Groundwater Transfer Review Summary Form

Transfer/PA # T- 13510

Application: T-13510

Applicant Name: Lynne Chamberlain

Figure 2. Cross sectional diagrams of wells, including well construction and lithology from well logs.

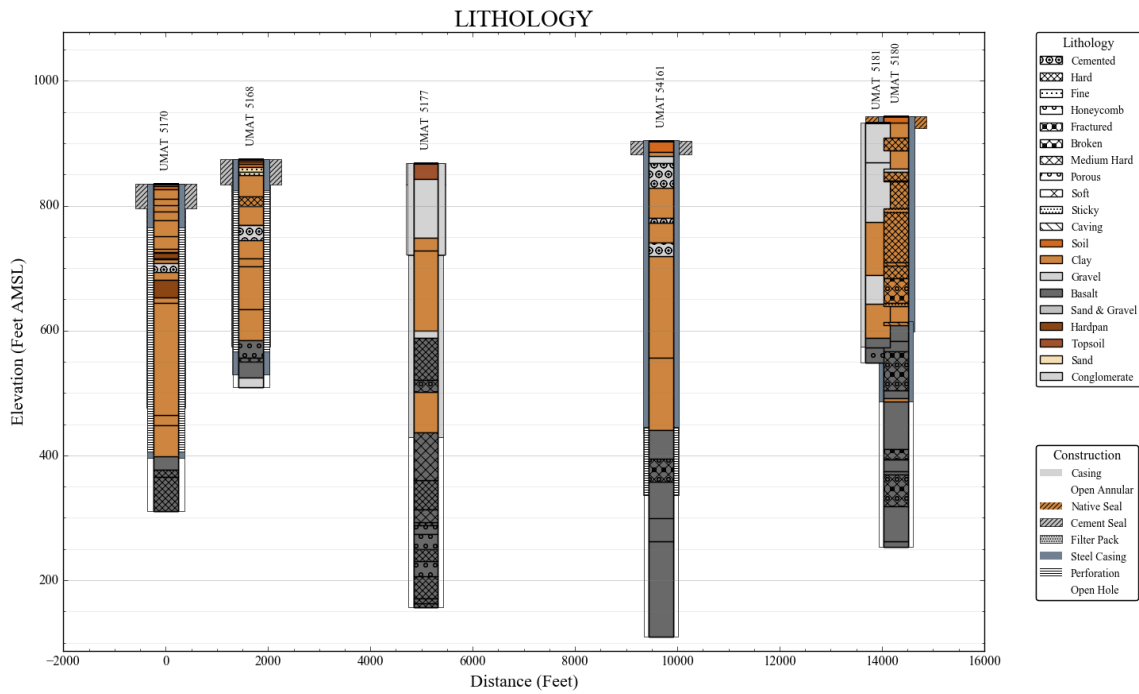
2. Will the proposed POA develop the same aquifer (source) as the existing authorized POA?
 Yes No Comments: As shown in Figure 2, UMAT 5181 is 385 feet deep, while UMAT 5180 is 690 feet deep. UMAT 5181 was drilled in 1945, and there is no record of a seal; UMAT 5180 was drilled in 1966 and is reportedly sealed 0-20 feet below land surface. There are no recent water level data available from either well. This review concludes the two wells are open roughly from land surface to 385 feet below land surface, which potentially allows contributions from both sedimentary and basaltic water-bearing zones. There is not enough information available to determine UMAT 5180 accesses distinctly different aquifers below 385 feet. Water level data are sparse, but nearby wells that access basalt below 385' do not show distinct water levels that indicate a clear separation between the basalt aquifer above 385' and between 385 and 690 feet BLS (see Figure 3).

Figure 3. Hydrograph of nearby wells.

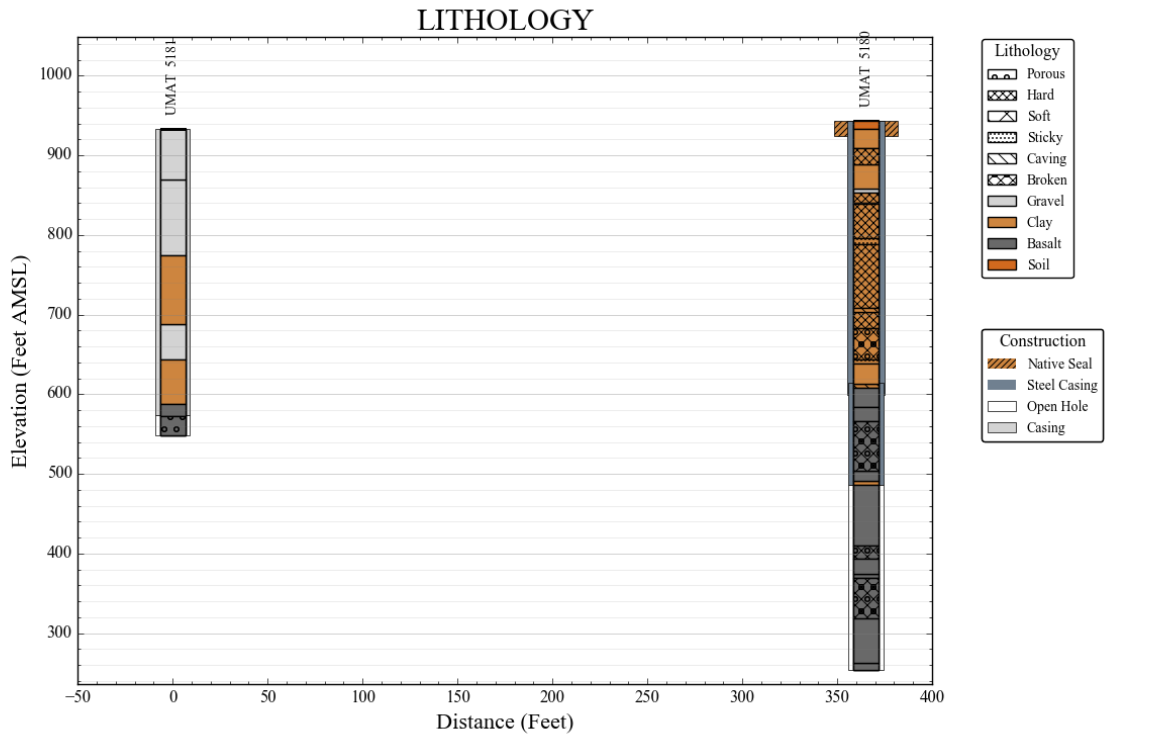
- b) If yes, estimate the portion of the right supplied by each of the sources and describe any limitations that will need to be placed on the proposed change (rate, duty, etc.): This is unknown. The historic water level elevations at UMAT 5180 and 5181 are similar to nearby deep basalt wells (see UMAT 5177 and UMAT 54161), therefore the primary source of water is likely basalt.
